## **Summary of Change in Revision 6 of the Safety Analysis Report for the Model MST-30 Package**

The safety analysis report for the model MST-30 package (abbreviated as“SAR”) has been revised from Rev.5 to Rev.6.

Revision Comparison Table for MST-30 SAR

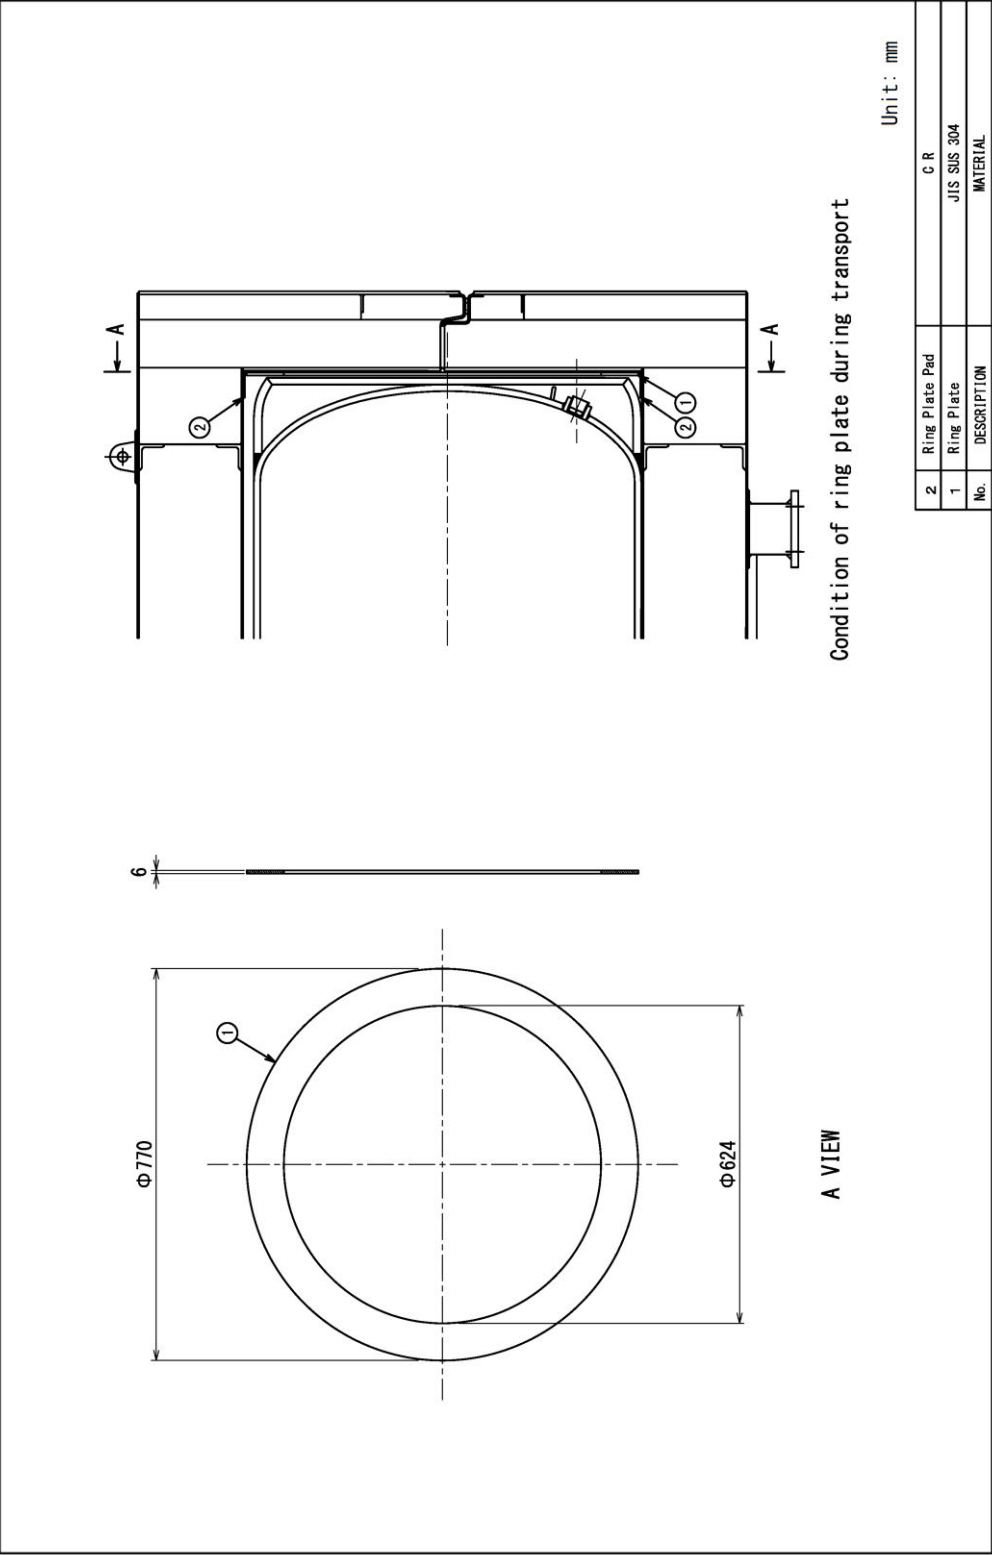
| page                                      | SAR Revision 5 (December 2014)  | SAR Revision 6 (March 2020)  | Note  |
|---|---|--|---|
| (2014 Vα)<br>1-4<br><br>(2020 Vα)<br>1-5  | 1.2.2 <u>Operational Features</u><br><br>The principal design features of MST-30 overpack are as follows: <ul style="list-style-type: none"> <li>Valve Pocket - sufficient space is provided around the valve to prevent direct contact of the valve with any other component of the packaging for Normal and Hypothetical Accident Conditions (HAC) without the need for a valve protection device (VPD);</li> <li>...</li> <li>Impact Limiters – Closed-cell, high-density polyurethane foam is used in both end walls of the overpack to maintain appropriate energy absorption and impact resistance to protect the valve or plug from damage.</li> </ul> | 1.2.2 <u>Operational Features</u><br><br>The principal design features of MST-30 overpack and ring plate are as follows: <ul style="list-style-type: none"> <li>Valve Pocket - sufficient space is provided around the valve to prevent direct contact of the valve with any other component of the packaging for Normal and Hypothetical Accident Conditions (HAC) without the need for a valve protection device (VPD);</li> <li>...</li> <li>Impact Limiters – Closed-cell, high-density polyurethane foam is used in both end walls of the overpack to maintain appropriate energy absorption and impact resistance to protect the valve or plug from damage.</li> <li>Ring Plate – A ring plate is inserted in the gap on the plug side between the overpack and the 30B cylinder. The ring plate is used to prevent the internal end plate on plug side of the overpack from excessively deforming in the HAC. In the case of a 30B cylinder with no plug, use of a ring plate is optional.</li> </ul> | Addition of a description of the Ring Plate |

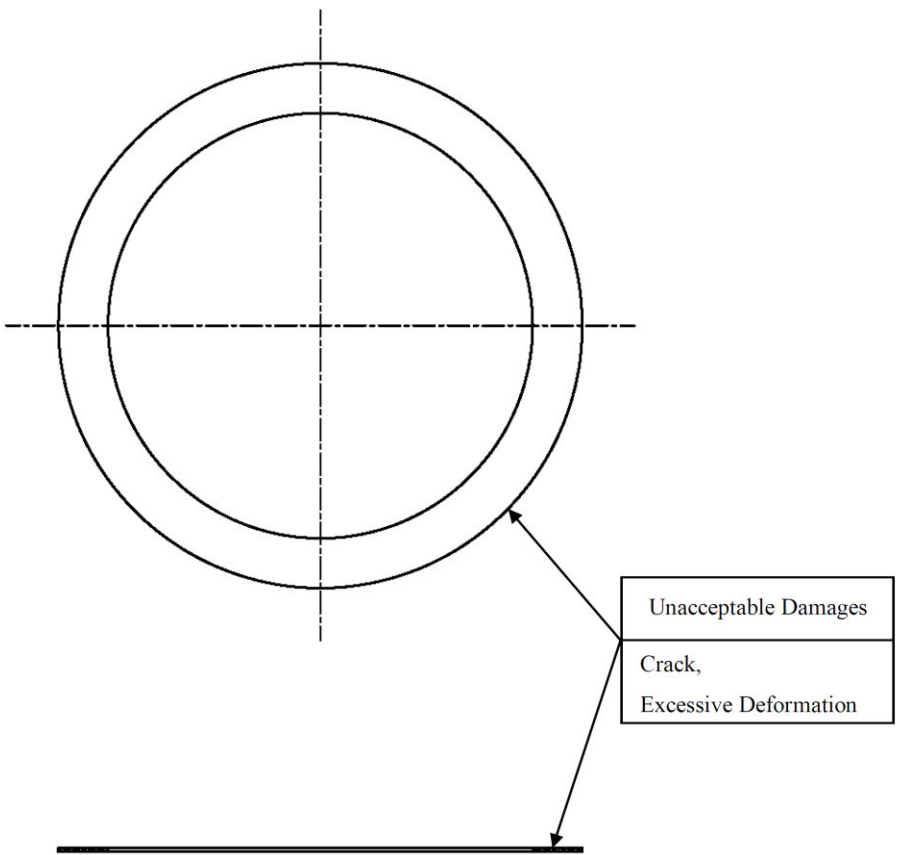
| Page | SAR Revision 5 (December 2014)   | SAR Revision 6 (March 2020)  | Note  |
|------|--|--|---|
| 7-2a | <p>7.1.5 <u>Procedure for Loading the MST-30 Overpack</u></p> <p>(a) The inspection required by Section 7.1.2 shall be performed and documented prior to loading a 30B cylinder into the overpack.</p> <p>(b) Carefully lift the 30B cylinder horizontally, directing the cylinder-valve toward the inner shell of the wall end of the bottom half on which step-joint the cylinder positioning device is installed. Then, carefully load the cylinder into the bottom half with the cylinder-valve positioned up at one (1) o'clock position. Then, securely insert the pin of cylinder positioning device into the hole of cylinder-skirt; otherwise the top half (lid) is prevented from proper seating and closure due to contact with the pin of positioning device located on the bottom half.</p> | <p>7.1.5 <u>Procedure for Loading the MST-30 Overpack</u></p> <p>(a) The inspection required by Section 7.1.2 shall be performed and documented prior to loading a 30B cylinder into the overpack.</p> <p>(b) Carefully lift the 30B cylinder horizontally, directing the cylinder-valve toward the inner shell of the wall end of the bottom half on which step-joint the cylinder positioning device is installed. Then, carefully load the cylinder into the bottom half with the cylinder-valve positioned up at one (1) o'clock position. Then, securely insert the pin of cylinder positioning device into the hole of cylinder-skirt; otherwise the top half (lid) is prevented from proper seating and closure due to contact with the pin of positioning device located on the bottom half.</p> | 7.1 Procedures for Loading the Package      |
|      | <p>(c) Carefully place the top half on the bottom half of overpack.</p> <p>(d) Tighten all fastening devices alternating first corner-to-corner (4 devices) followed by side-to-side (6 devices).</p> <p>(e) Install tamper-proof seals and record their numbers.</p> <p>(f) Complete radiation survey and assign Transport Index as per applicable regulations.</p> <p>(g) Remove old labels and re-label following the applicable regulations.</p>   | <p>(c) Insert a ring plate into the gap on the plug side between the overpack and the 30B cylinder.</p> <p>(d) Carefully place the top half on the bottom half of overpack.</p> <p>(e) Tighten all fastening devices alternating first corner-to-corner (4 devices) followed by side-to-side (6 devices).</p> <p>(f) Install tamper-proof seals and record their numbers.</p> <p>(g) Complete radiation survey and assign Transport Index as per applicable regulations.</p> <p>(h) Remove old labels and re-label following the applicable regulations.</p>   | Addition of a description of the Ring Plate |
